COPPERSTRING EIS

Attachment F - Vegetation Clearing Works plans

Dajarra Road to Mount Isa

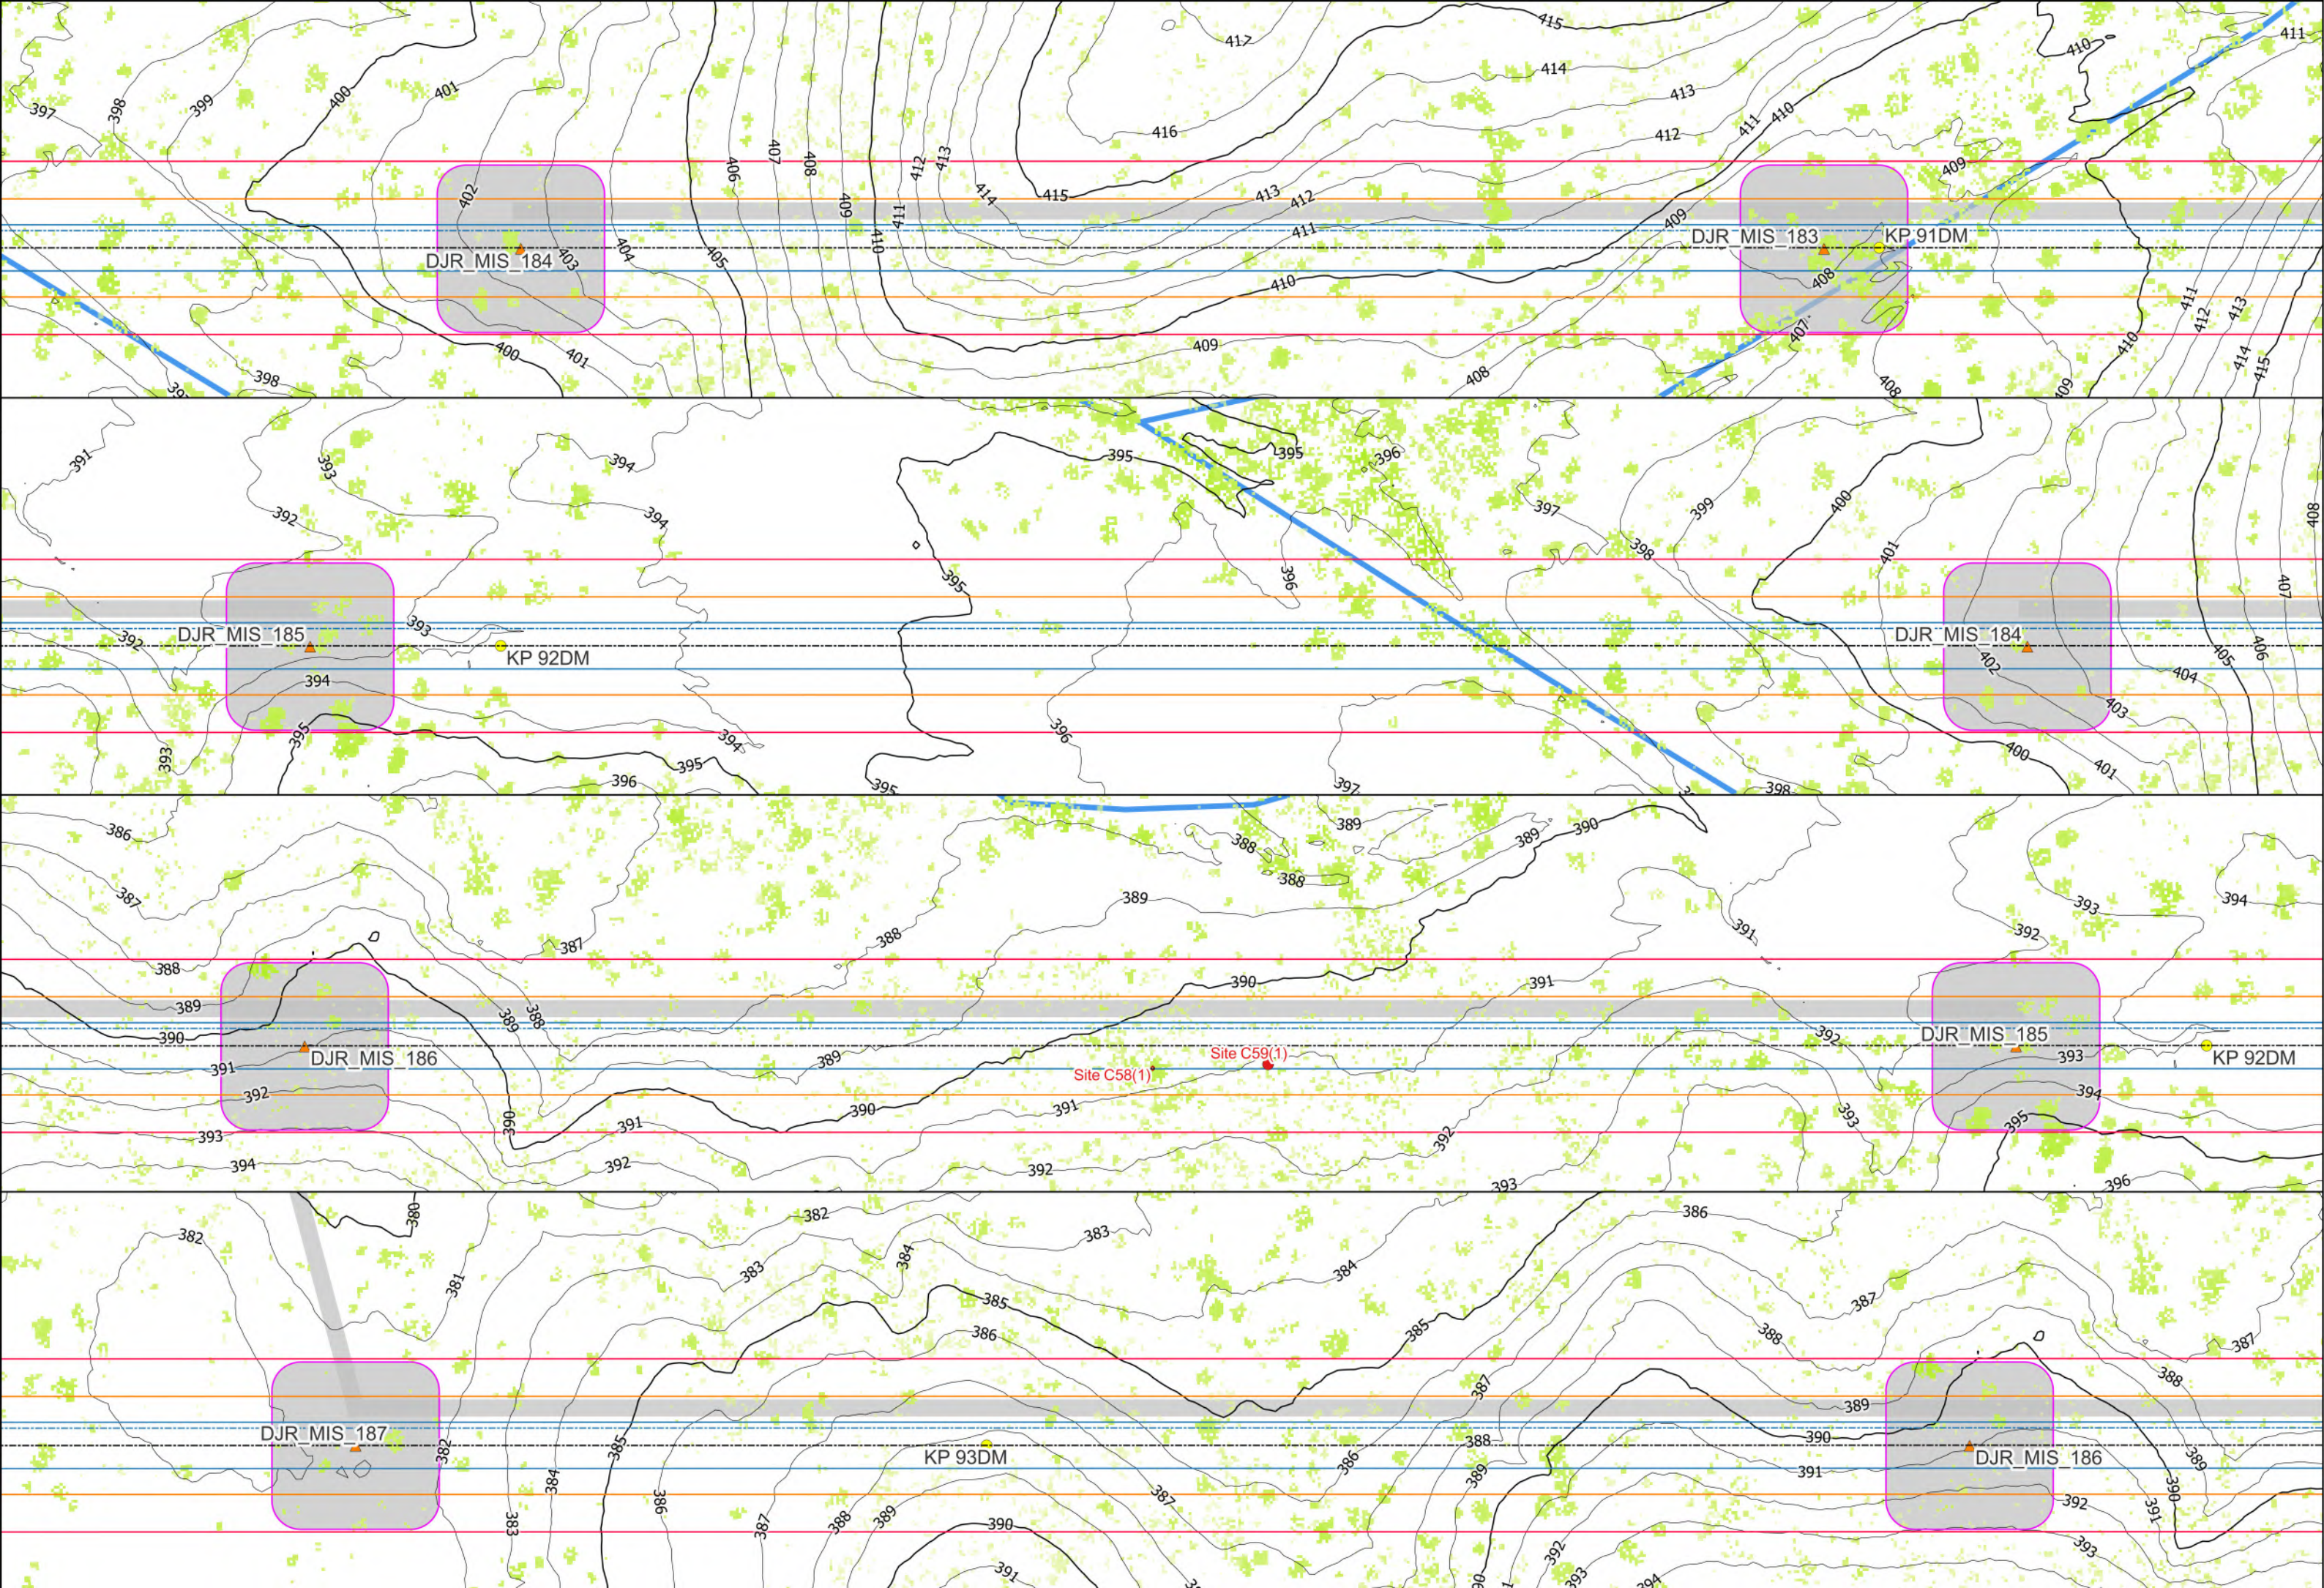
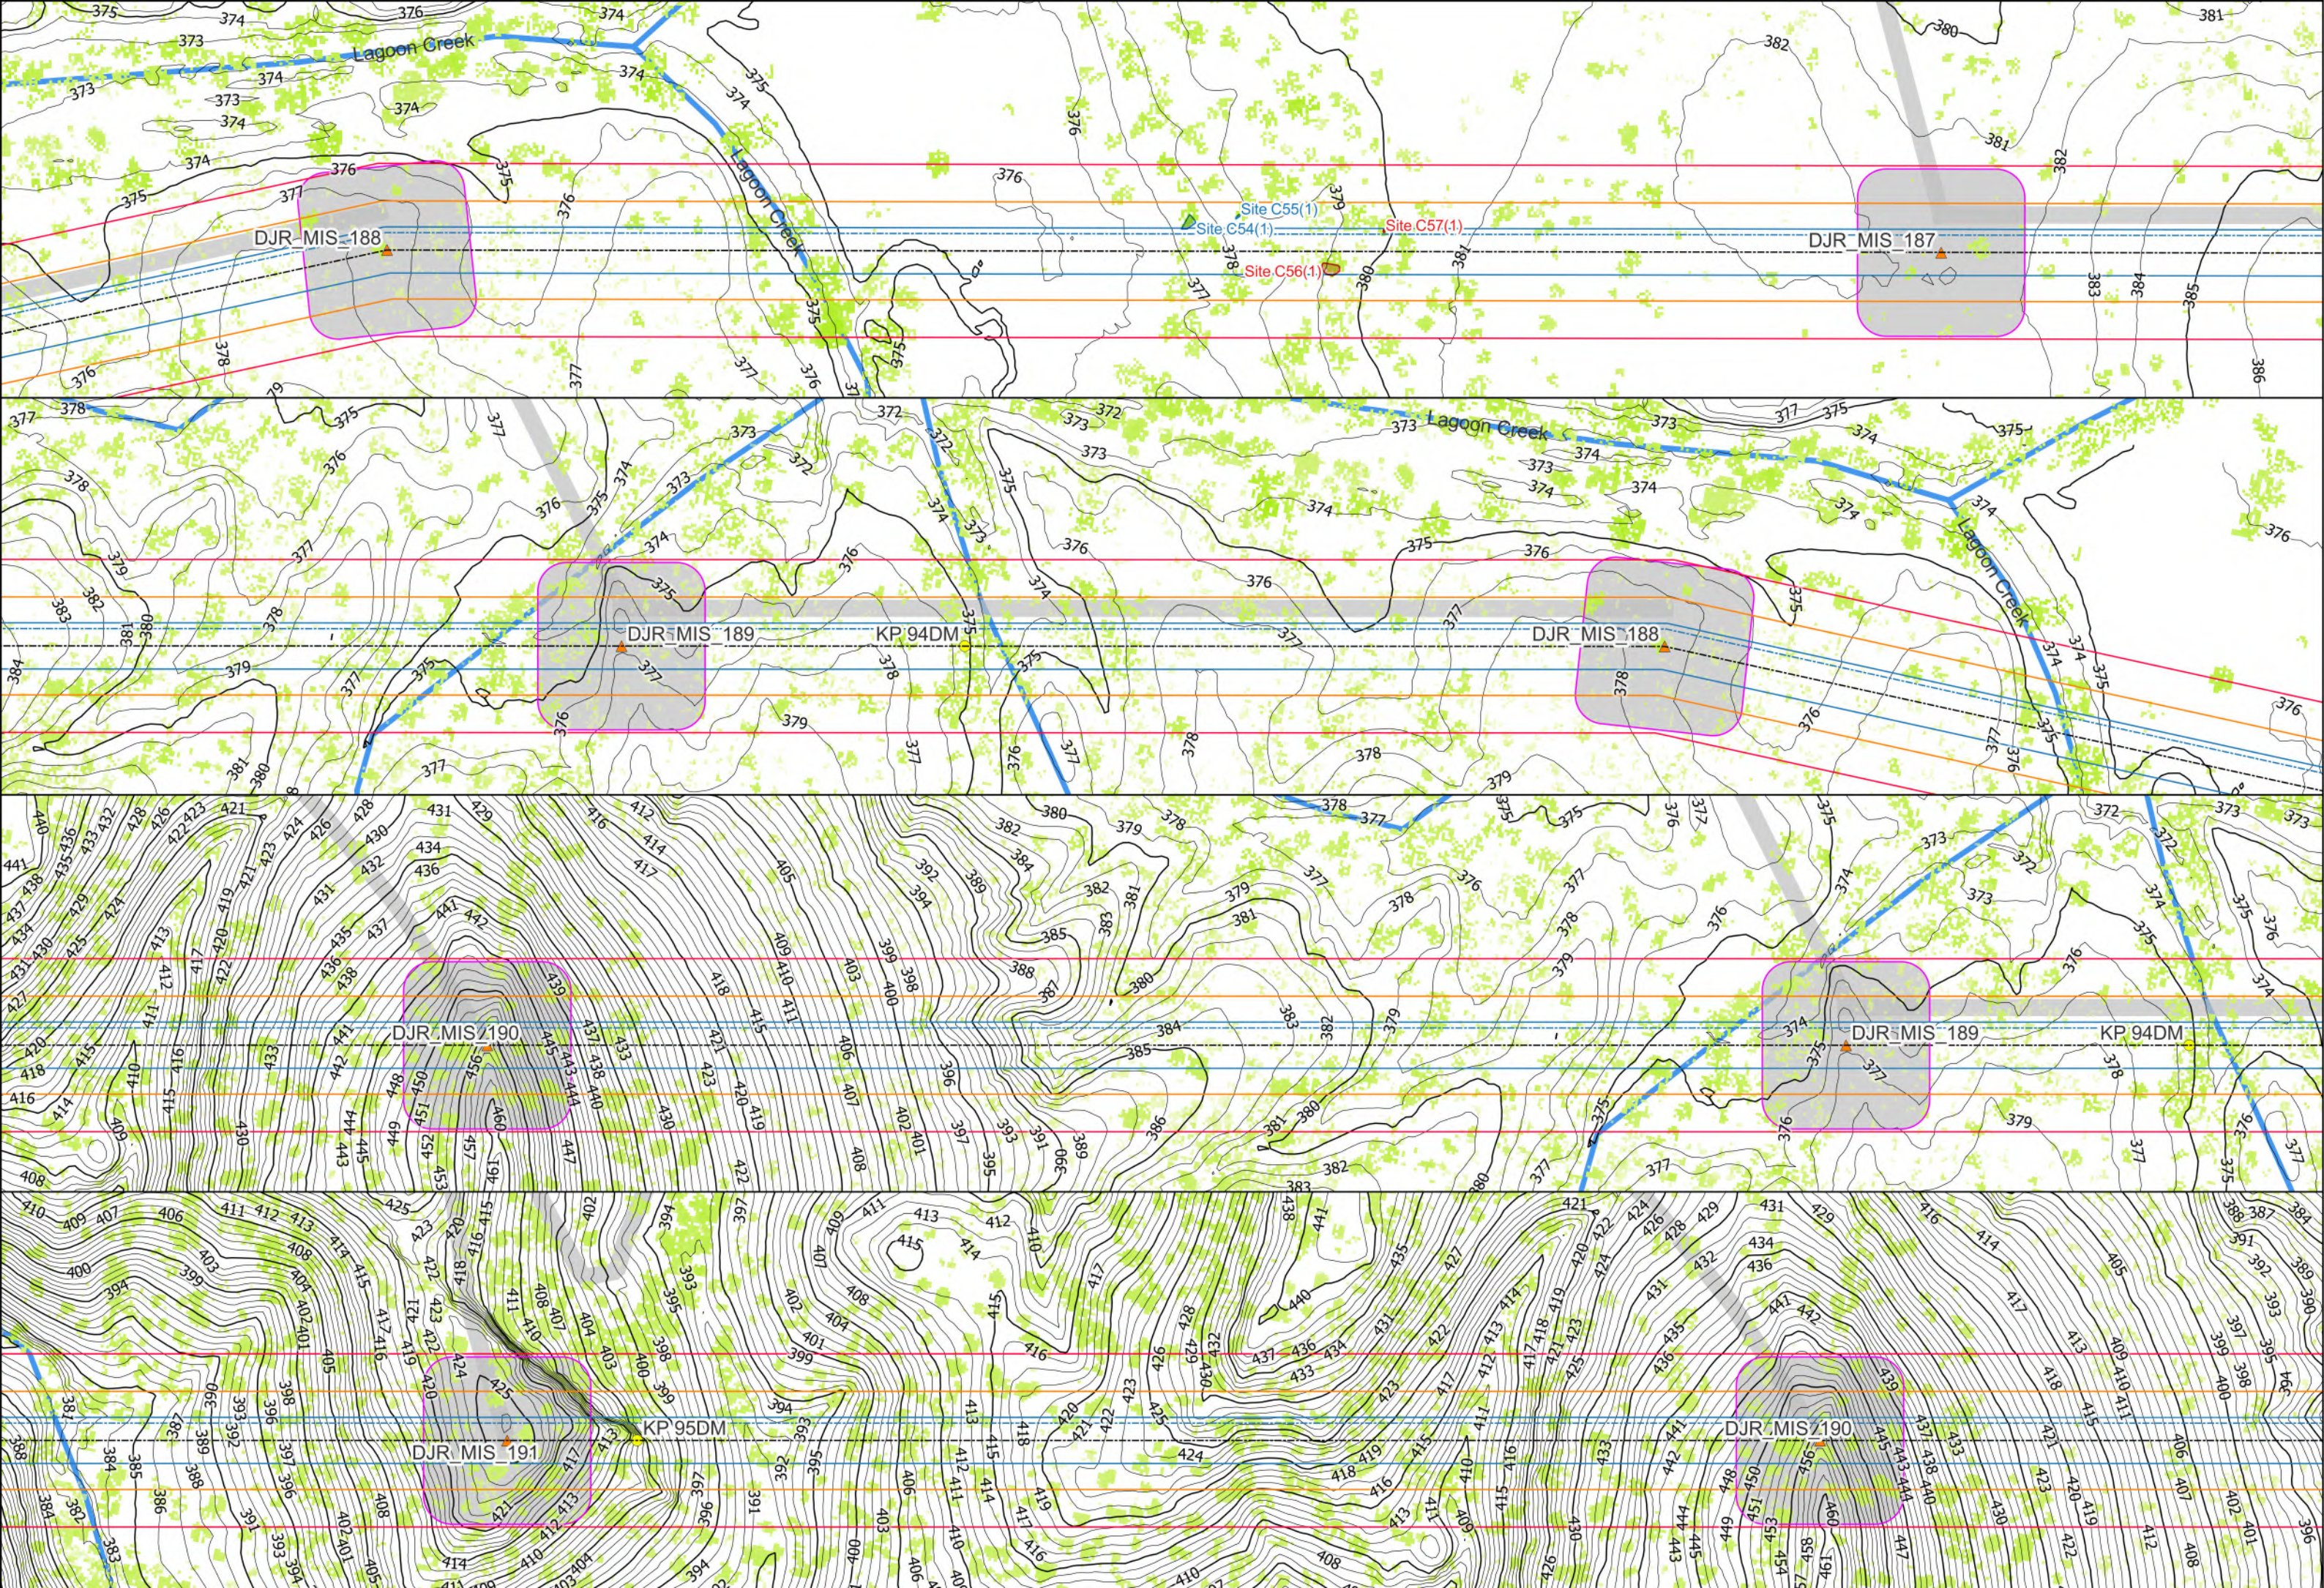
Tower assembly area to be reconfigured to not be within 15m of the high bank of waterway and to avoid clearing near or within the bed and banks for the waterway.

Tower height and placement to reviewed during detailed design to reduce clearing impacts to waterway. Clearing for conductor clearance to this High Risk (red) waterway occur above ground level to minimise disturbance to ground and roots which contribute to bank stability.

Tower height and placement to reviewed during detailed design to reduce clearing impacts to waterway. Clearing for conductor clearance to this Moderate Risk (amber) waterway occur above ground level to minimise disturbance to ground and roots which contribute to bank stability.

Position of Brake and winch to be reviewed during detailed design to relocated away from (daf) waterway.

Tower assembly area to be reconfigured to not be within 15m of the high bank of waterway and to avoid clearing near or within the bed and banks for the waterway.
